ZCWD SBAC SSTP SUPPLEMENTAL BID BULLETIN NO. 2022-003

Subject: PR No. 22-0113 – Design, Build, Testing & Commissioning of Proposed 4,000 CMD Sewage & Septage Treatment Plant

In response to the inquiries of **JZ Aguiba Construction and Technical Services, Inc.**, dated **August 8, 2022**, thru email, please see the below answers:

PHOTOGRAPHS OF AS-BUILT PLAN OF THE SEWAGE PUMPING STATIONS

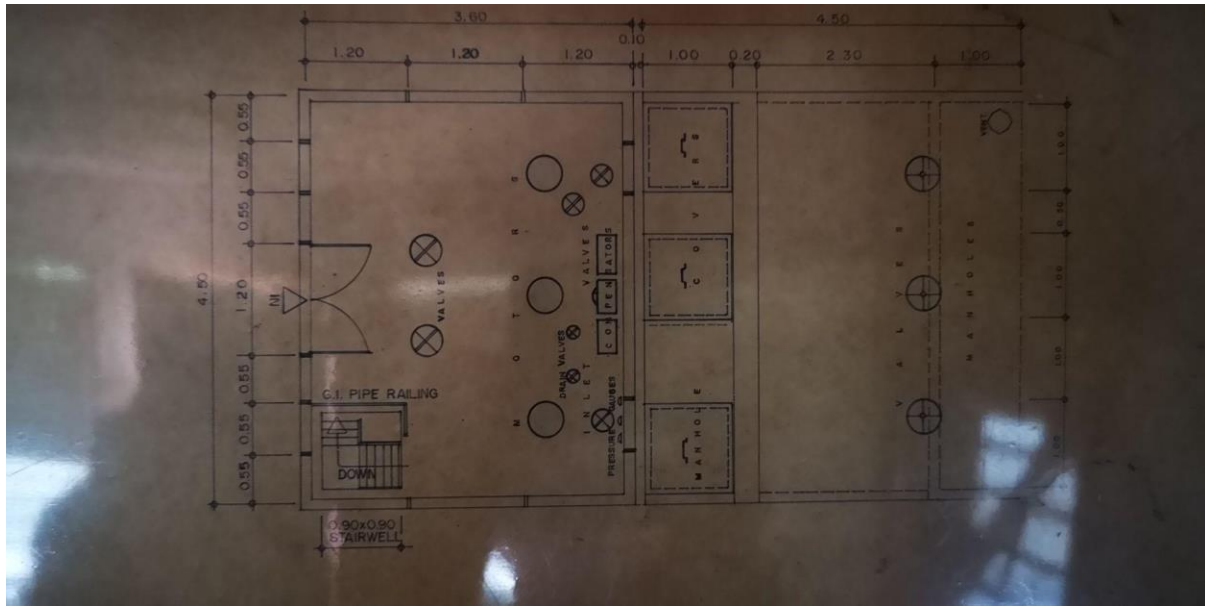
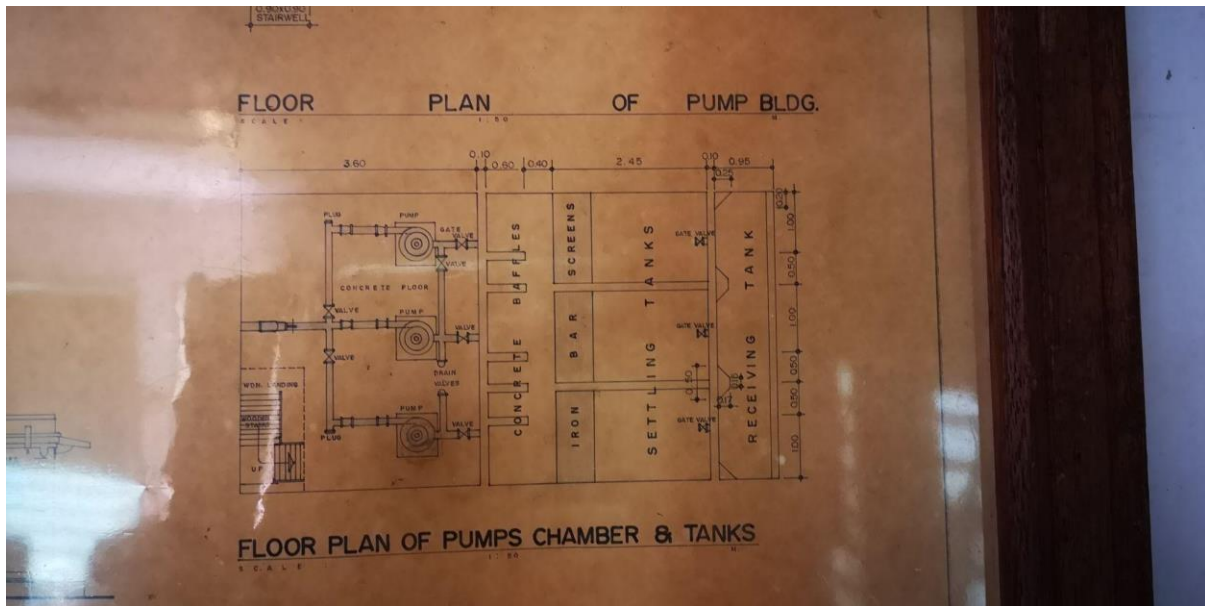
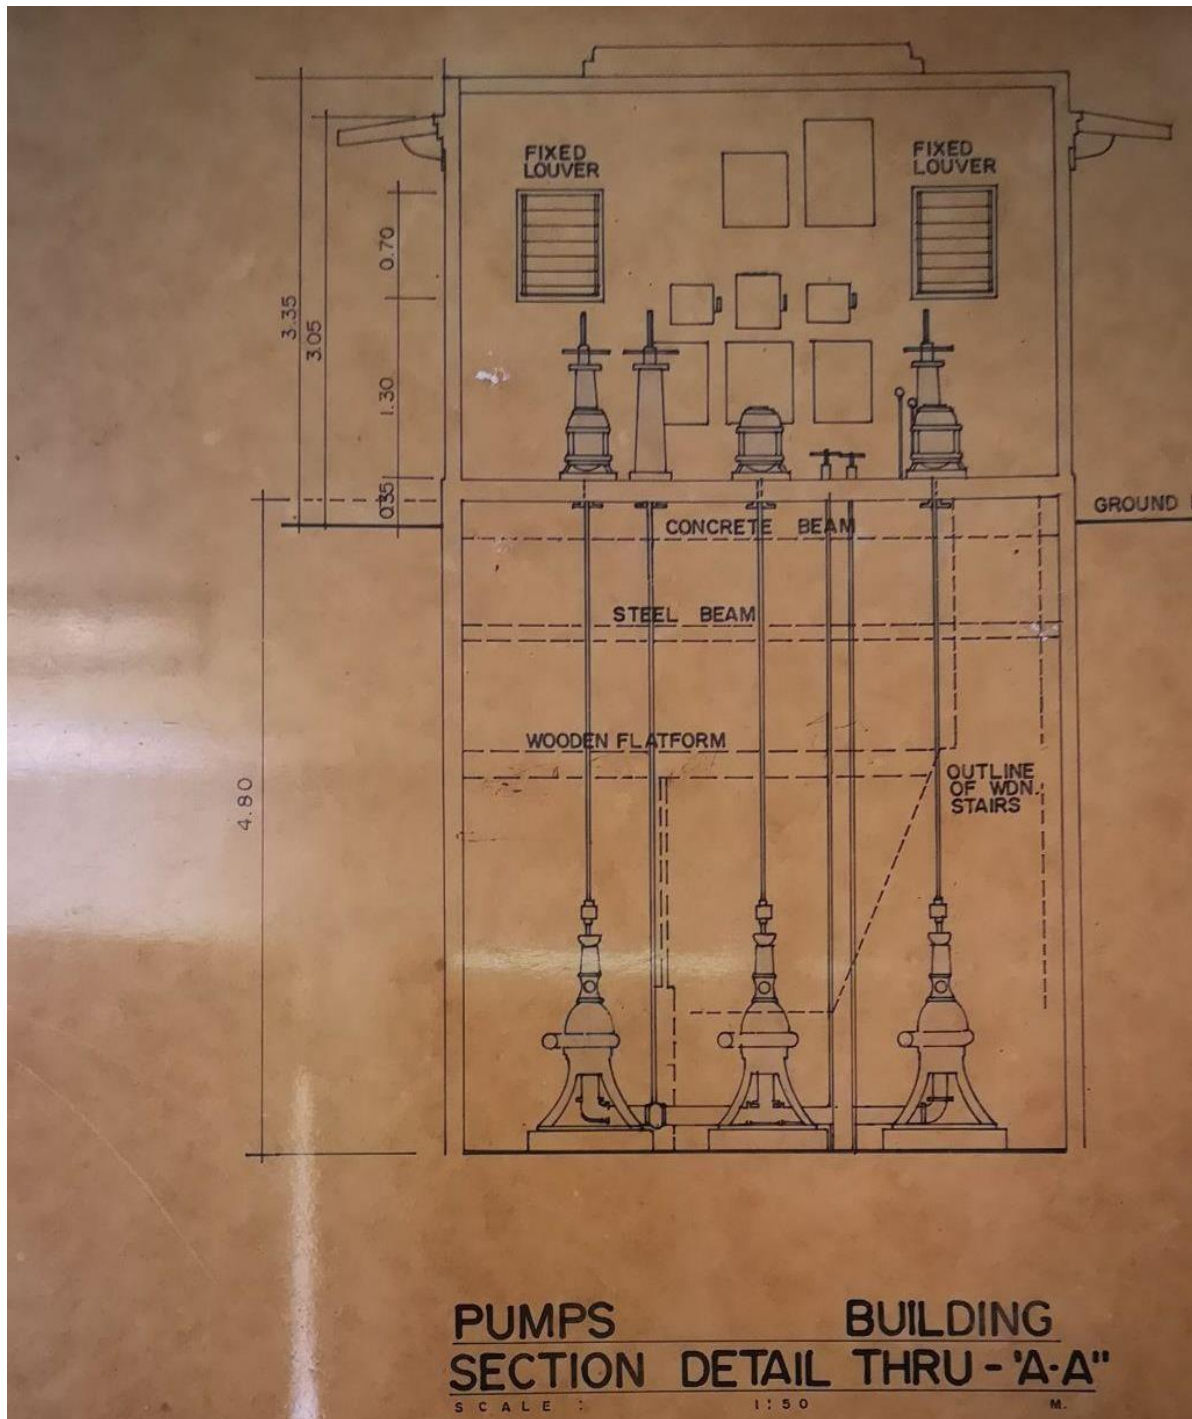
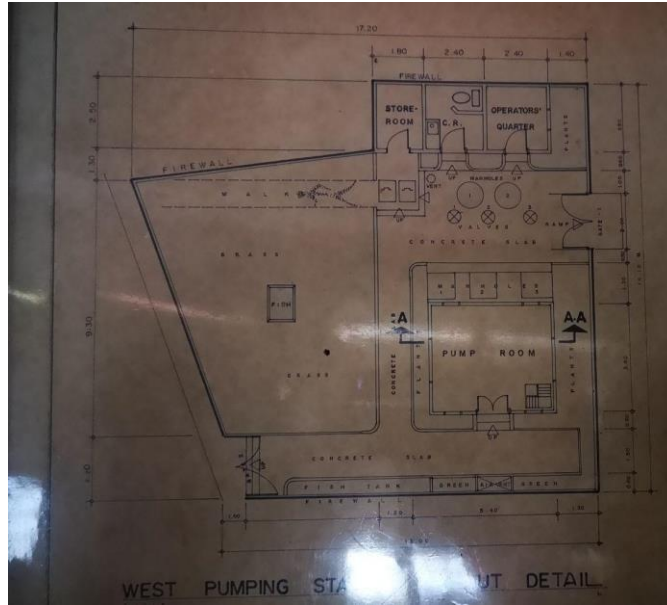
17. Please provide a copy of as-built plans of the WPS and MRF	<p>As the PSs were constructed in the early 30's, as the as-built plan was preserved by framing them. This is currently hanged at East Pumping Stations and there are no electronic copies thereof. Attached here are the photographs of the as-built plans of the pumping stations.</p> <p>As to the MRF, the ZCWD does not have possession of its as-built plans. For reference, a layout of the MRF is annexed in the Revised Performance Specifications.</p>
